## Southern California Flower Market Project

Environmental Case: ENV-2016-3991-EIR  
State Clearinghouse No.: 2017051068

Figure 4: 2014 Statewide All Fleet Sizes (Pieces of Equipment)

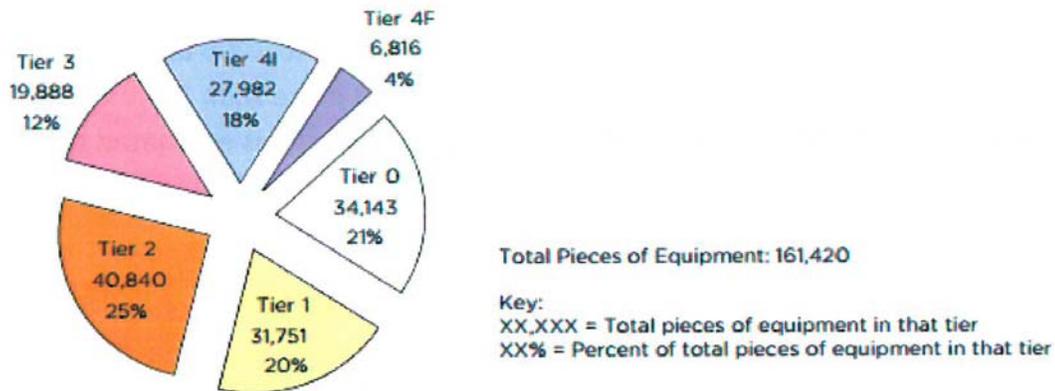
As demonstrated in the figure above, Tier 4 Interim and Tier 4 Final equipment only accounts for 18% and 4%, respectively, of all off-road equipment currently available in the state of California. Thus, by stating that the Project proposes to use Tier 4 equipment during construction, the DEIR's analysis is relying on a fleet of construction equipment that only accounts for 22% of all off-road equipment currently available in the state of California. Therefore, by failing to evaluate the feasibility of implementing Tier 4 mitigation into the Project's construction phases, the Project's construction emissions are unverified. Thus, the significance determination made within the Air Quality analysis should not be relied upon to determine Project significance.
